**DEVIATION REQUEST
 AND DECISION FORM**

Project Name :	Eagle Rising PCD File No. SP205 & SF2225
Schedule No.(s) :	52290-00-034 & 52290-00-035
Legal Description :	See Attached

A deviation from the standards of or in Section(s) **ECM 3.3.3 B and C** of the Engineering Criteria Manual (ECM) is requested.

HEC-RAS Cross Section Location and Photo Key Map

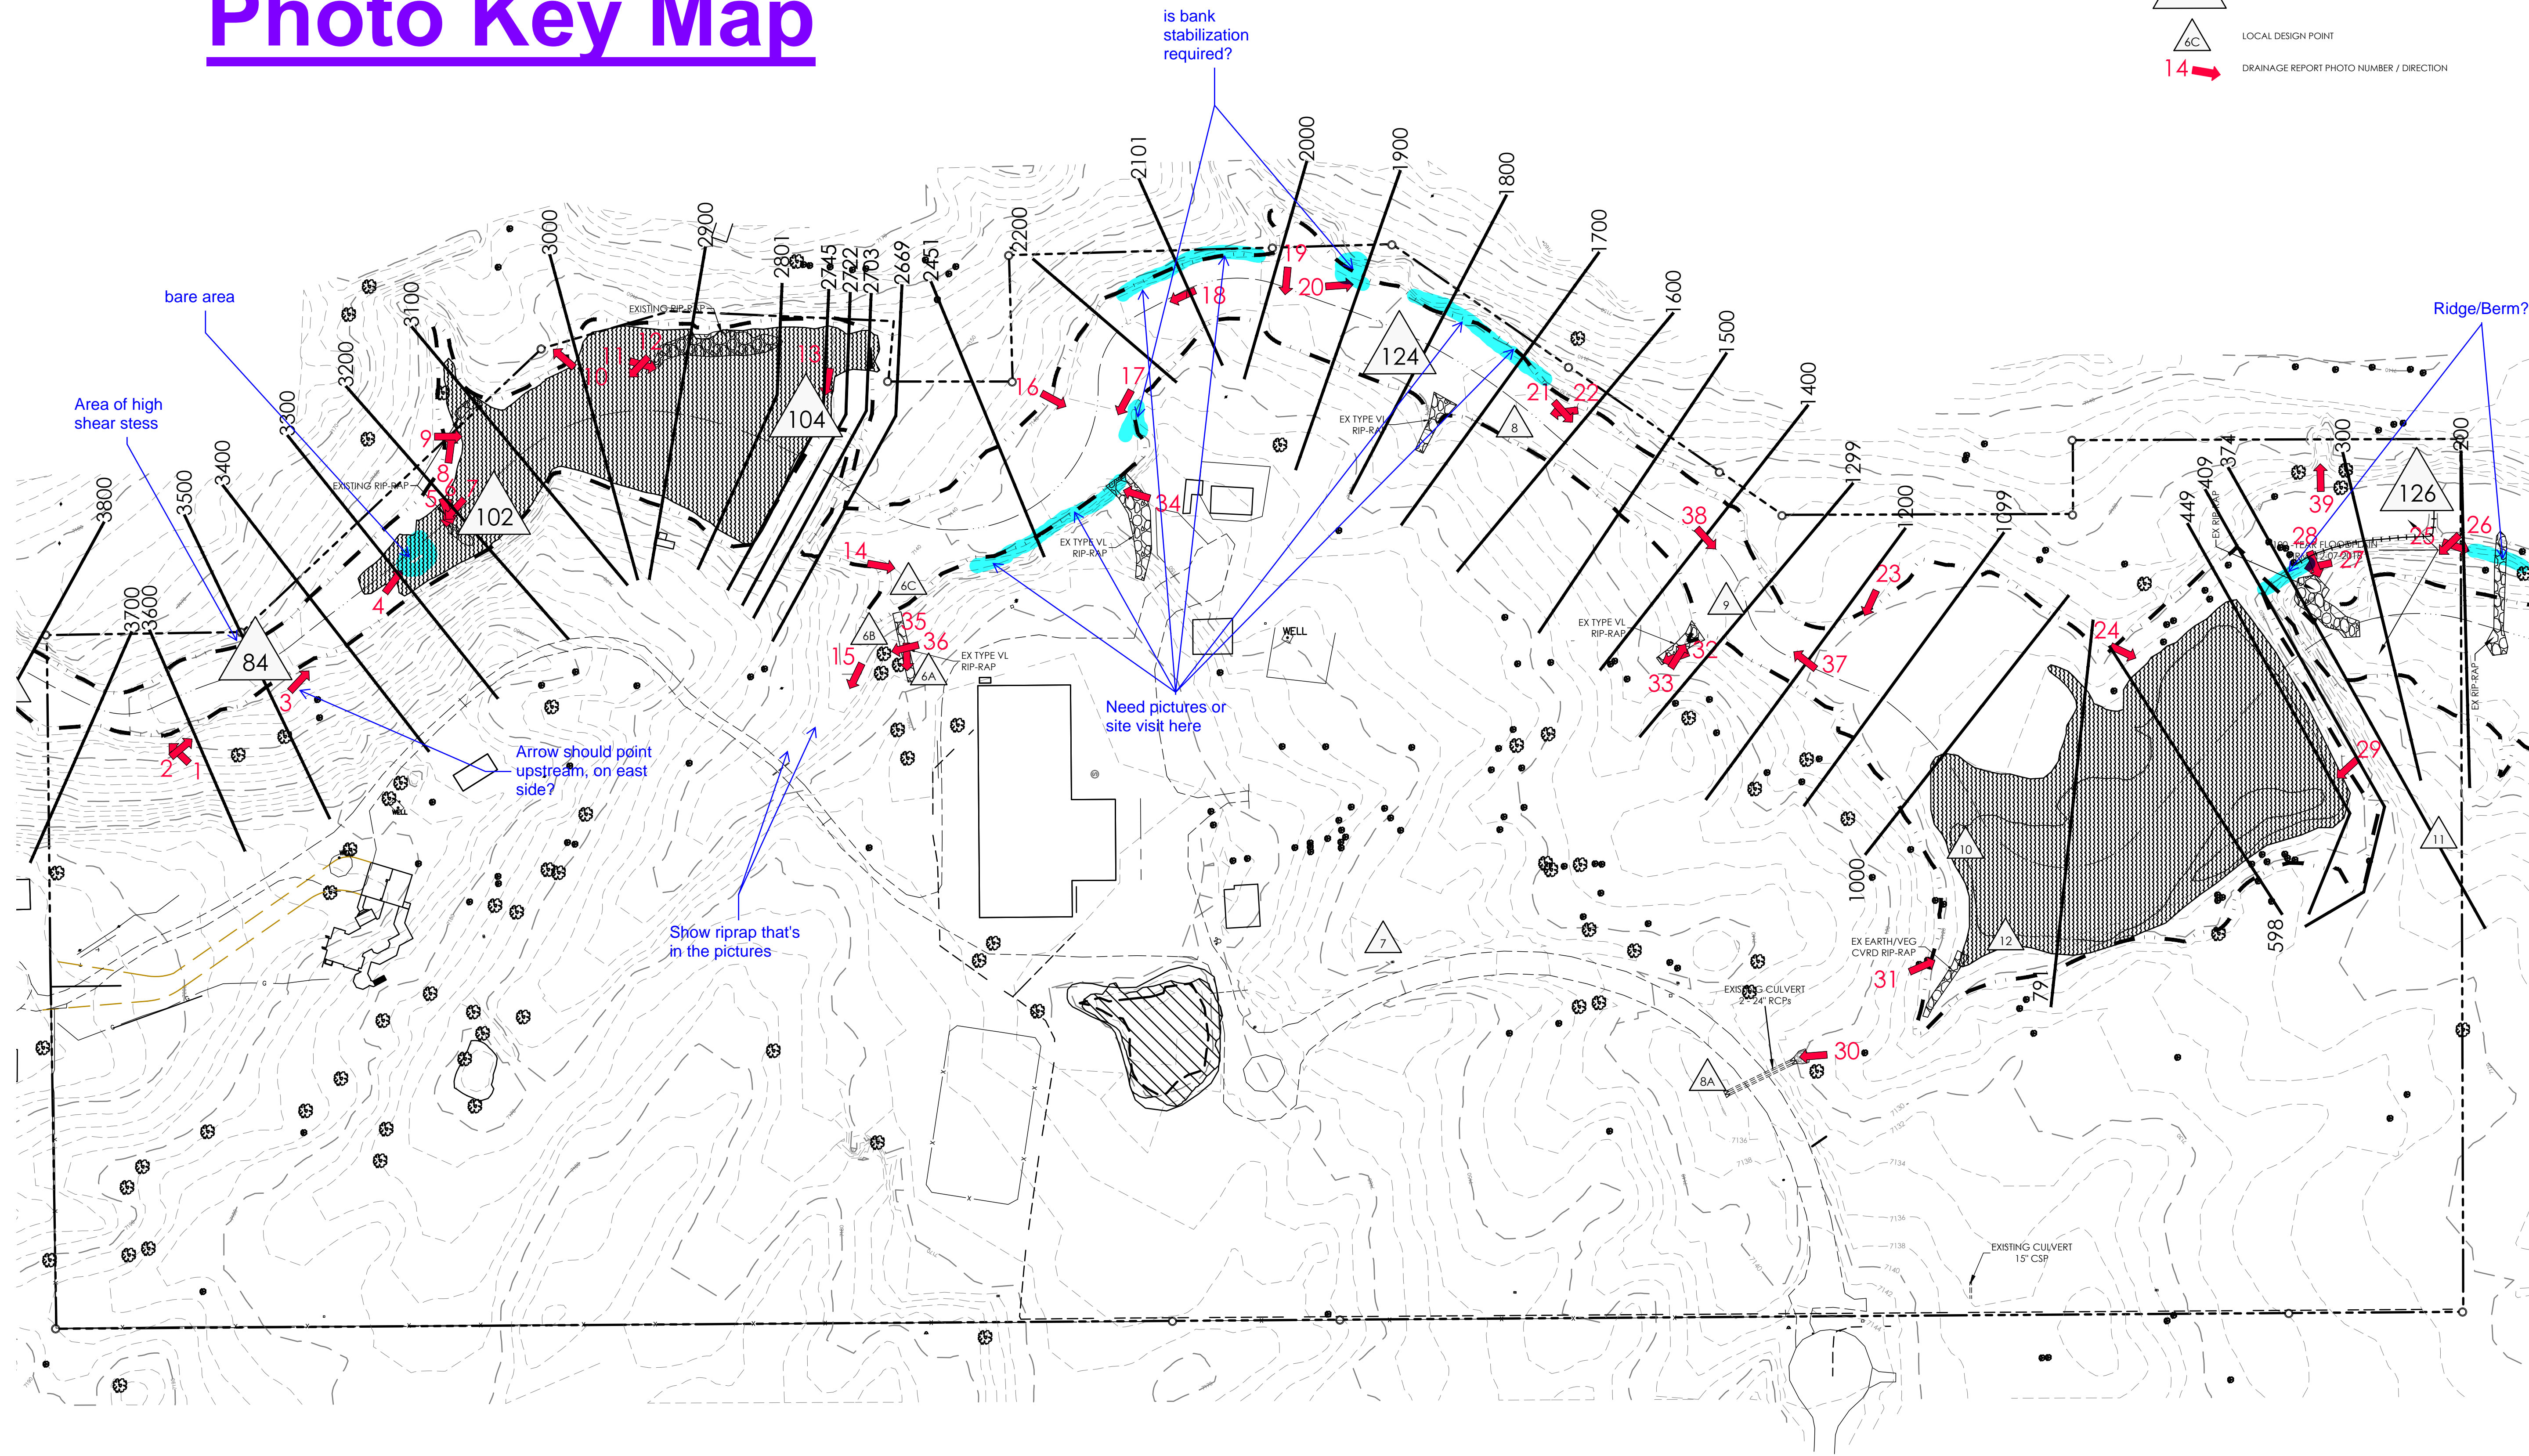
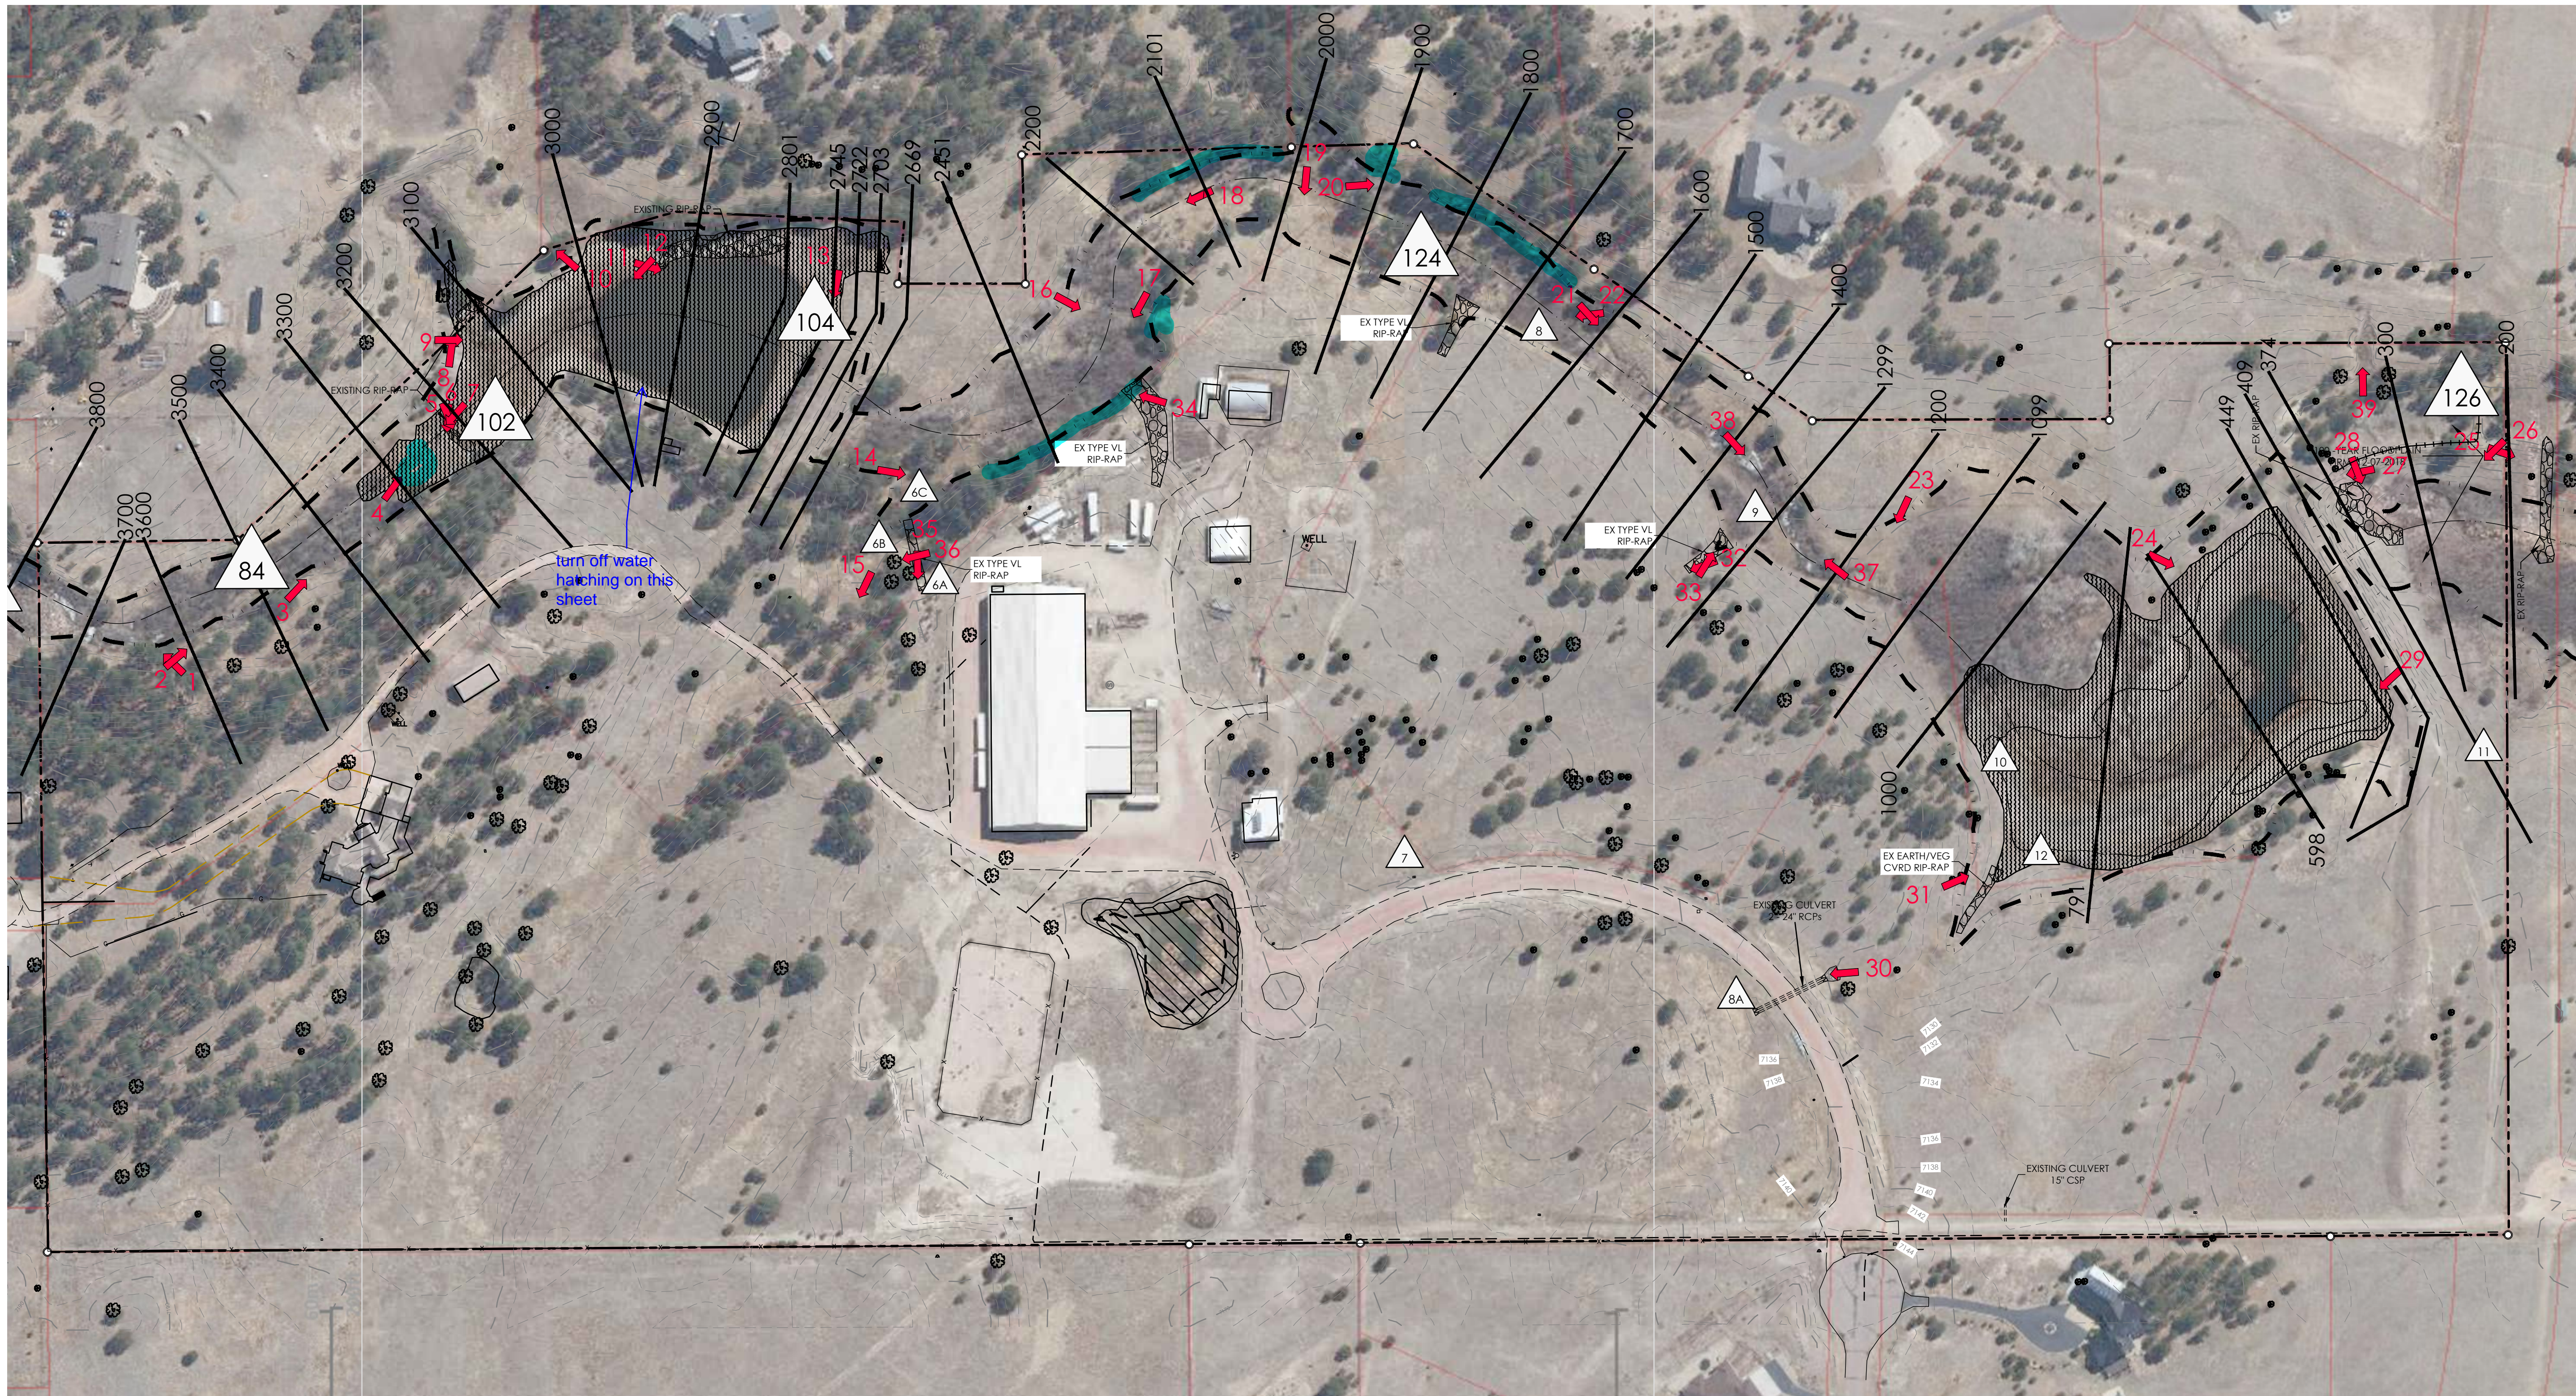
shear stresses modeled are higher in several areas; address those

as-built plans will need to be approved to verify usefulness
